Hillsborough Street (NC-54) Horne Street to Gorman/Faircloth Street

**Pedestrian Road Safety Assessment
Raleigh, North Carolina
April 21 – 22, 2009**

**Dan Nabors and Frank Gross
Vanasse Hangen Brustlin (VHB), Inc**

Figure 3. Rendering of Hillsborough Street Redesign Project between Pogue Street and Gardner Street.

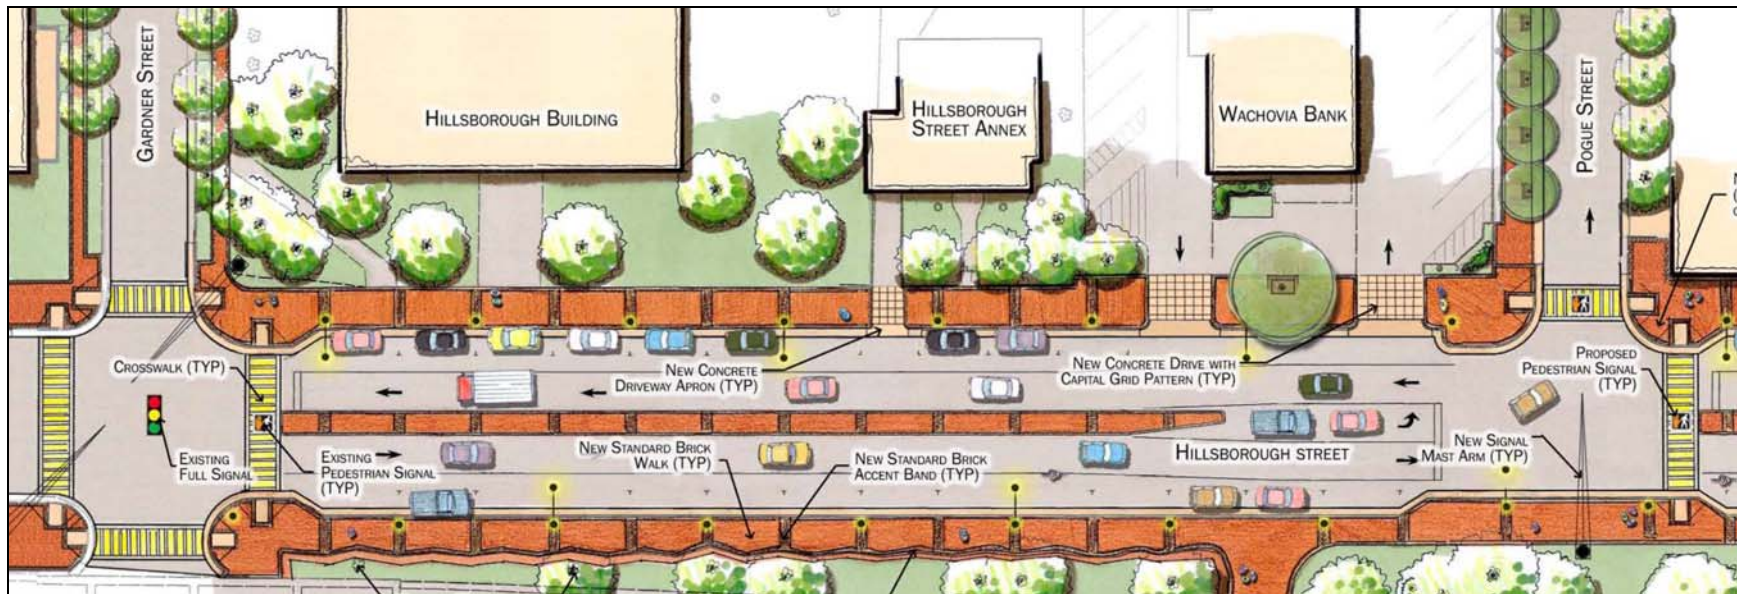
Figure 3 illustrates a portion of the Hillsborough Street Redesign Project. Phase 1 of the project includes the section of Hillsborough Street between Pullen Road and Gardner Street. There are several improvements planned as part of the project, including:

- **Streetscape** – A streetscape is planned for both the north and south sides of Hillsborough Street. Parking will be allowed on both sides of the street and will help to separate pedestrian traffic from vehicular traffic. The majority of the median will have no landscaping, minimizing visual obstructions between pedestrians and vehicles.

- **Continuous Light-Emitting Diode (LED) Lighting** – There is currently lighting along the study corridor, but the city plans to install continuous LED lighting. Raleigh is part of the LED City initiative, which looks to upgrade all lighting sources with LED-based fixtures. The planned improvements will fill-in existing gaps in lighting, providing a more constant level of illumination. According to the City, the LED lights will provide improved acuity and recognition compared to the typical metal halide fixtures, which is advantageous in an area with high volumes of nighttime pedestrian activity.

- **Reduction of Speed Limit and Road Diet** – Currently Hillsborough Street operates under the citywide speed limit of 35 mph. As part of the improvement project, the speed limit will be reduced to 25 mph based on the two-lane cross-section with a median and on-street parking along both sides of the street. It should be noted that this will only apply to the Hillsborough Street Redesign Project area between Horne Street and Gardner Street.

- **Access Management** – The plans to install a median will help with access management, restricting left-turns into and out of access points located at midblock locations.

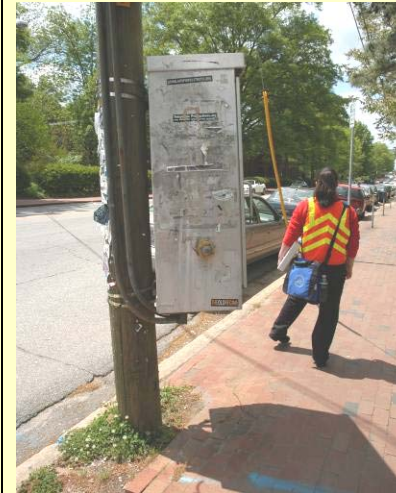
Insufficient pedestrian zone—there are several locations along Hillsborough Street, particularly along the north side, where the pedestrian zone is insufficient due to inconsistent sidewalk width and obstructions, including:

Photo shows where a hydrant is located in the middle of the curb ramp, obstructing access between the sidewalk and crosswalk.

Consider widening sidewalk to provide an unobstructed minimum 5-ft pedestrian zone. Features such as hydrants, traffic control cabinets, utility poles, etc, should be placed outside of this zone in the furniture zone or buffer zone between the pedestrian zone and the curb.

Long-term – Relocate hydrants or curb ramps and crosswalks to provide unobstructed access between the sidewalk and crosswalk.

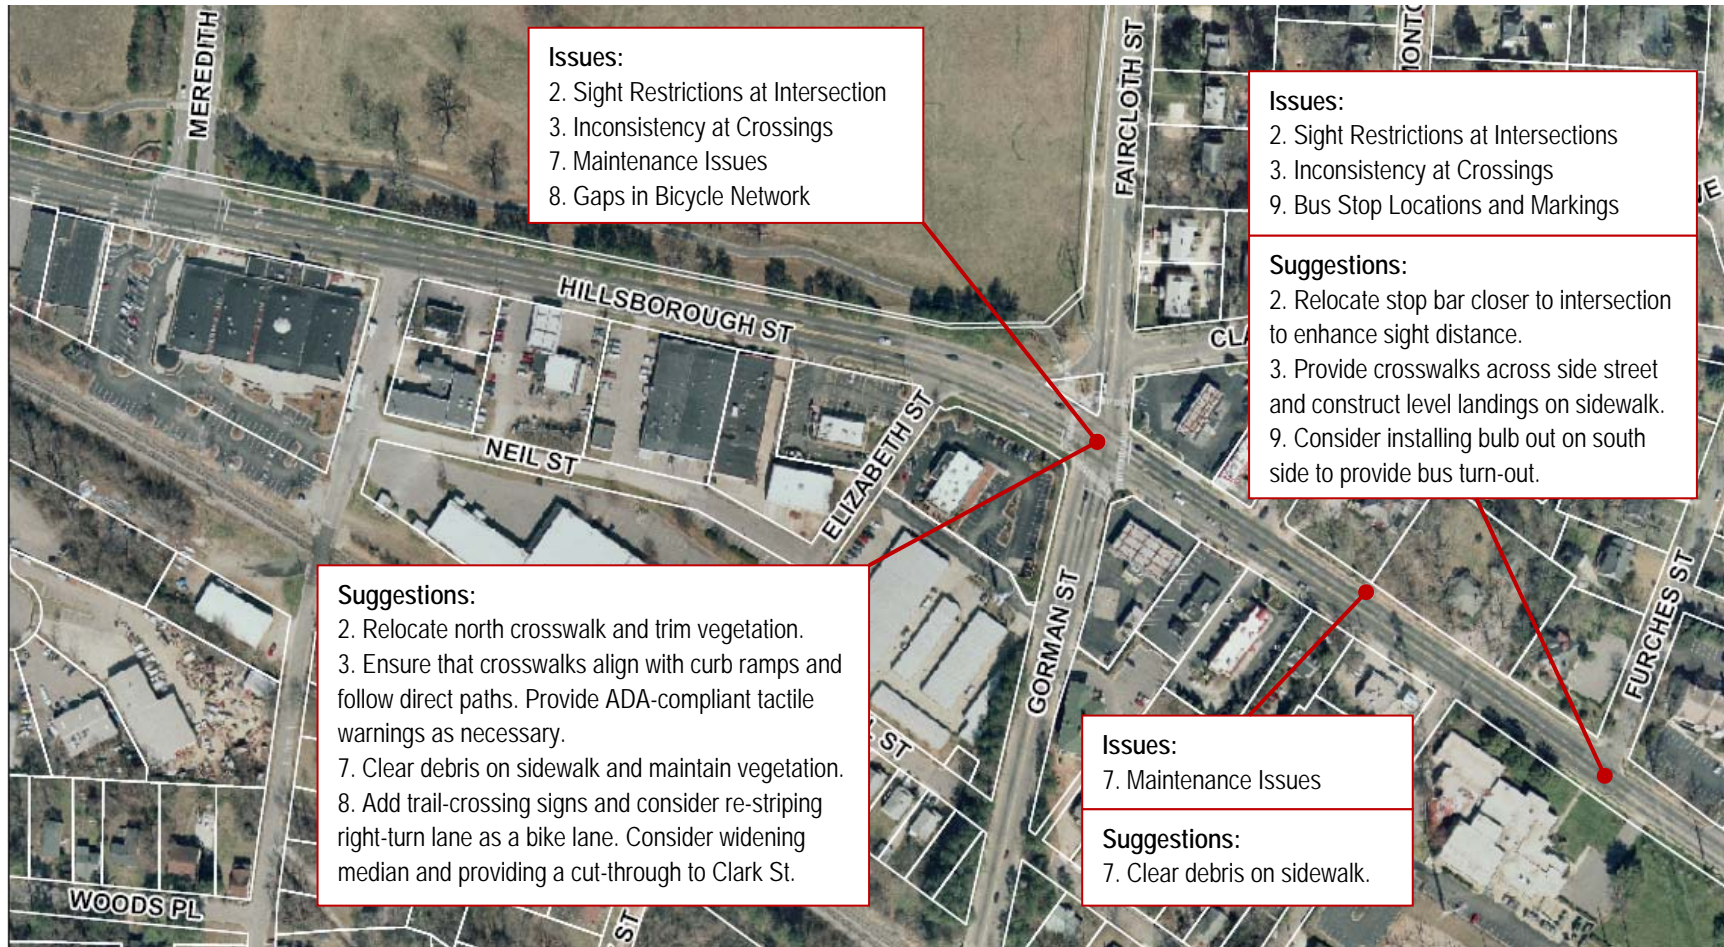
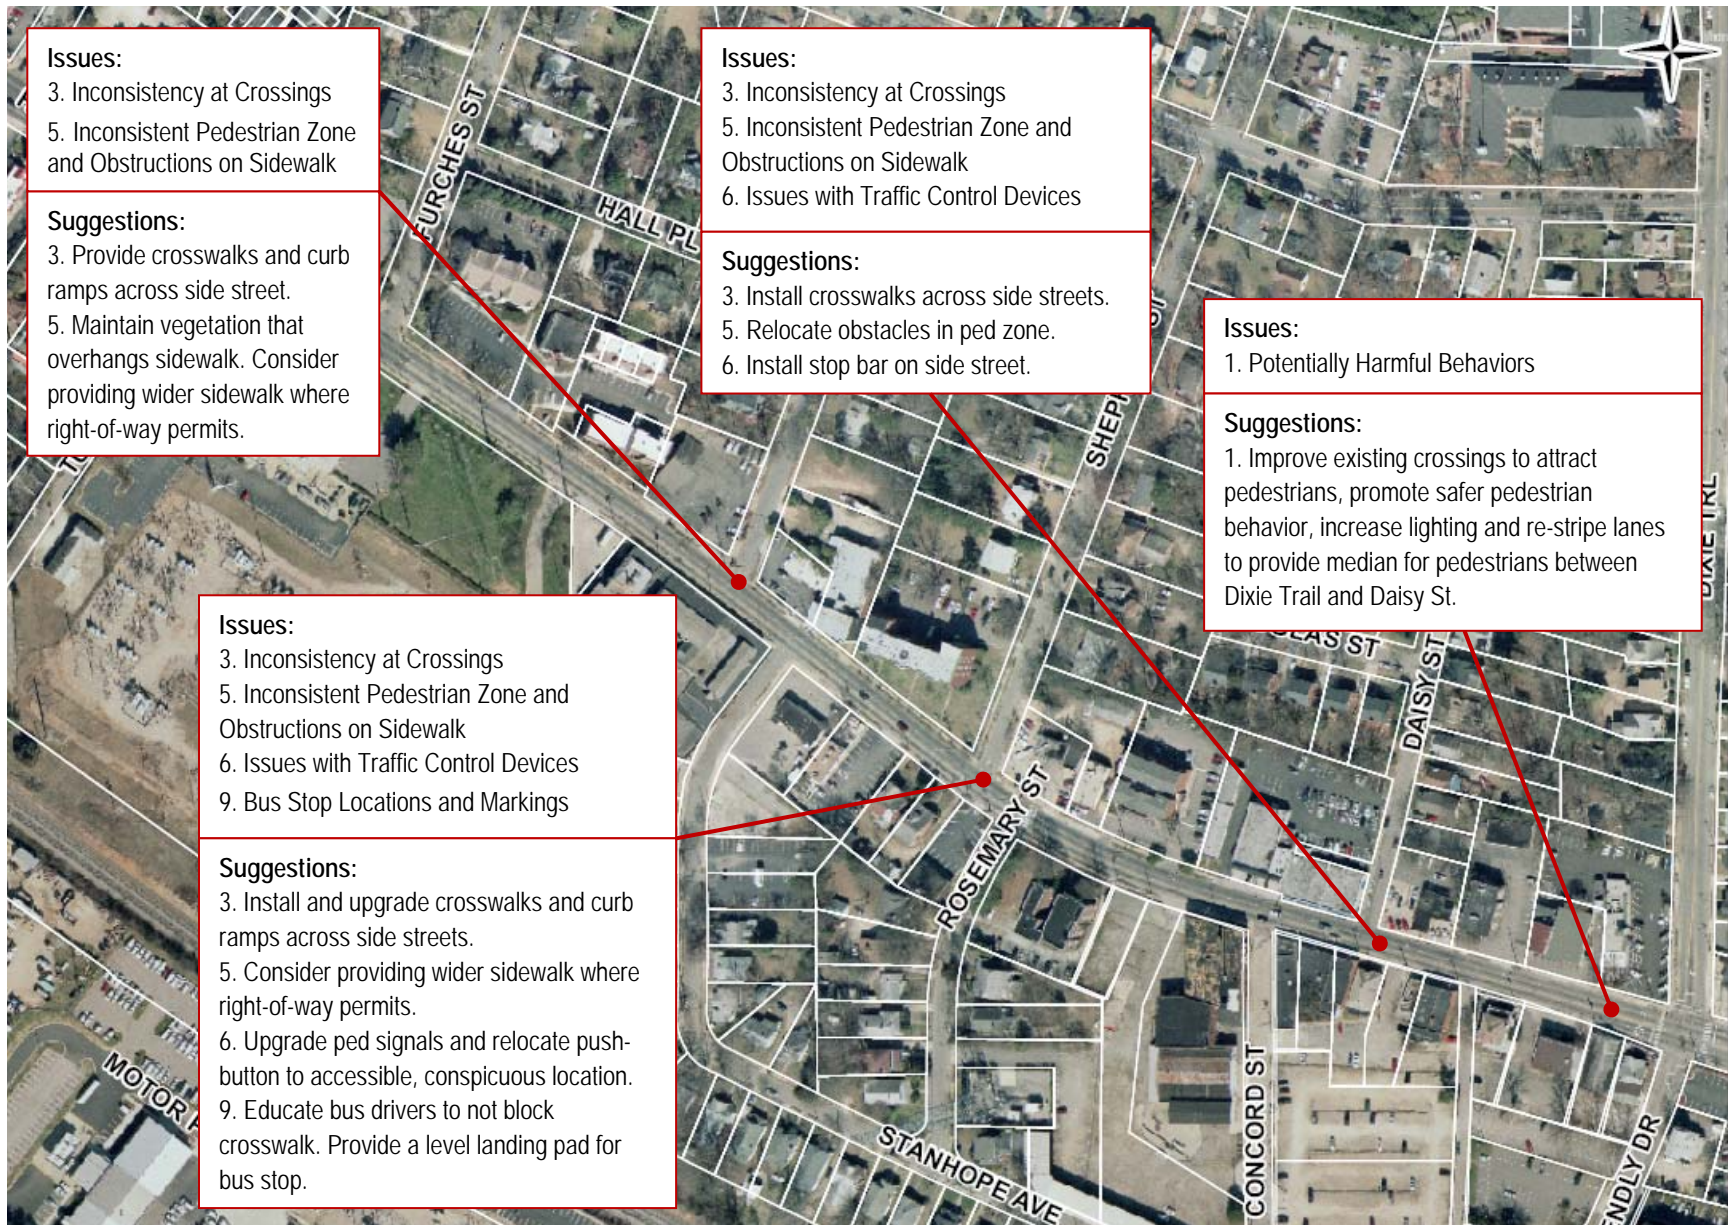
The following aerials provide an overview of the study area as well as the safety issues and suggestions identified by the RSA team. The issues and suggestions are numbered in reference to the issues identified in Table 1. For example, the following aerial shows the intersection of Hillsborough St. and Gorman St. with four issues, numbered 2, 3, 7, and 8. These issues correspond to the respective issues (2, 3, 7, and 8) in Table 1 and the suggestions are labeled to correspond with the appropriate issue.

Issues:

- 3. Inconsistency at Crossings
- 5. Inconsistent Pedestrian Zone and Obstructions on Sidewalk

Issues:

- 3. Inconsistency at Crossings
- 5. Inconsistent Pedestrian Zone and Obstructions on Sidewalk
- 6. Issues with Traffic Control Devices

Issues:

- 1. Potentially Harmful Behaviors

Suggestions:

- 3. Provide crosswalks and curb ramps across side street.
- 5. Maintain vegetation that overhangs sidewalk. Consider providing wider sidewalk where right-of-way permits.

Suggestions:

- 3. Install crosswalks across side streets.
- 5. Relocate obstacles in ped zone.
- 6. Install stop bar on side street.

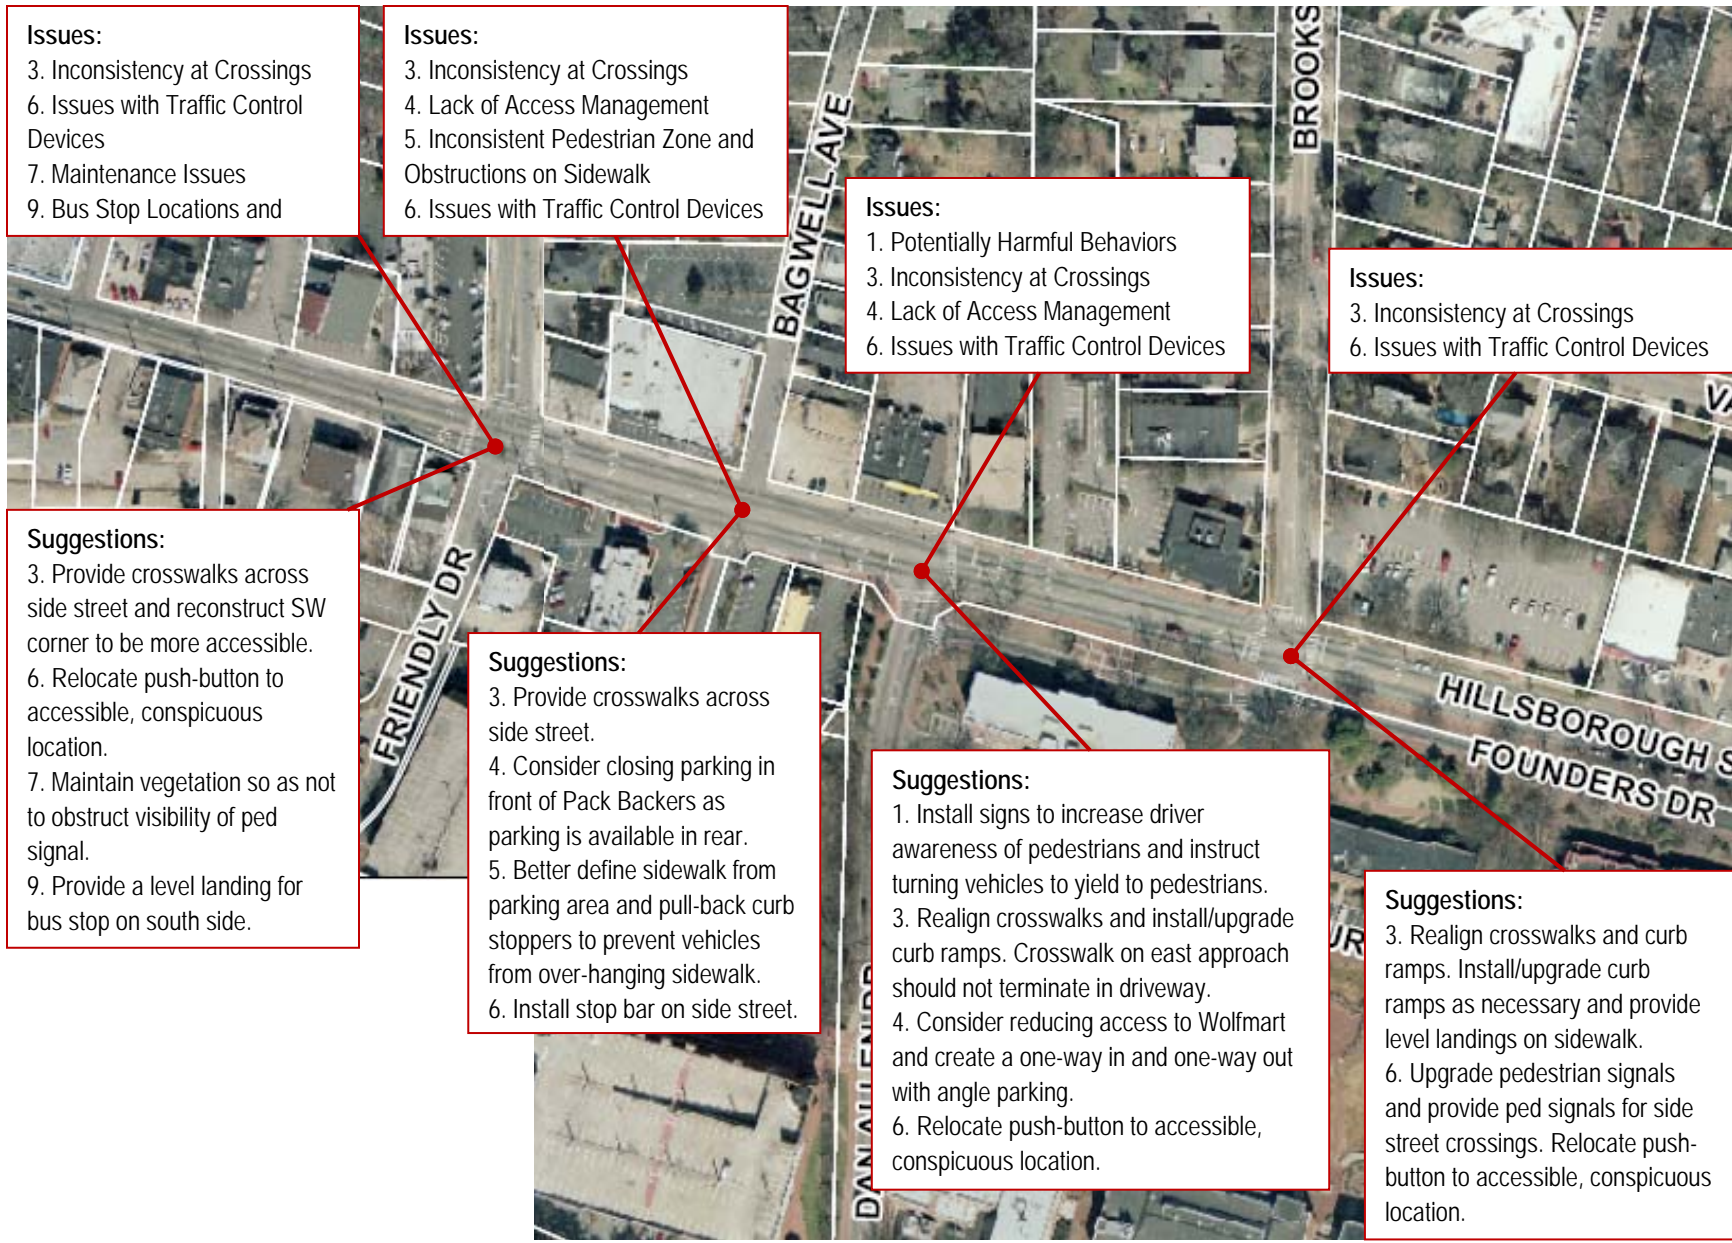
Issues:

- 3. Inconsistency at Crossings
- 5. Inconsistent Pedestrian Zone and Obstructions on Sidewalk
- 6. Issues with Traffic Control Devices
- 9. Bus Stop Locations and Markings

Issues:

- 3. Inconsistency at Crossings
- 6. Issues with Traffic Control Devices
- 7. Maintenance Issues
- 9. Bus Stop Locations and

Issues:

- 3. Inconsistency at Crossings
- 4. Lack of Access Management
- 5. Inconsistent Pedestrian Zone and Obstructions on Sidewalk
- 6. Issues with Traffic Control Devices

Issues:

- 1. Potentially Harmful Behaviors
- 3. Inconsistency at Crossings
- 4. Lack of Access Management
- 6. Issues with Traffic Control Devices

Issues:

- 3. Inconsistency at Crossings
- 6. Issues with Traffic Control Devices

- 1. Improve existing crossings to attract pedestrians, promote safer pedestrian behavior, increase lighting and re-stripe lanes to provide median for pedestrians between Dixie Trail and Daisy St.

- 3. Install and upgrade crosswalks and curb ramps across side streets.
- 5. Consider providing wider sidewalk where right-of-way permits.
- 6. Upgrade ped signals and relocate push-button to accessible, conspicuous location.
- 9. Educate bus drivers to not block crosswalk. Provide a level landing pad for bus stop.

- 3. Provide crosswalks across side street and reconstruct SW corner to be more accessible.
- 6. Relocate push-button to accessible, conspicuous location.
- 7. Maintain vegetation so as not to obstruct visibility of ped signal.
- 9. Provide a level landing for bus stop on south side.

- 3. Provide crosswalks across side street.
- 4. Consider closing parking in front of Pack Backers as parking is available in rear.
- 5. Better define sidewalk from parking area and pull-back curb stoppers to prevent vehicles from over-hanging sidewalk.
- 6. Install stop bar on side street.

- 1. Install signs to increase driver awareness of pedestrians and instruct turning vehicles to yield to pedestrians.
- 3. Realign crosswalks and install/upgrade curb ramps. Crosswalk on east approach should not terminate in driveway.
- 4. Consider reducing access to Walmart and create a one-way in and one-way out with angle parking.
- 6. Relocate push-button to accessible, conspicuous location.

- 3. Realign crosswalks and curb ramps. Install/upgrade curb ramps as necessary and provide level landings on sidewalk.
- 6. Upgrade pedestrian signals and provide ped signals for side street crossings. Relocate push-button to accessible, conspicuous location.
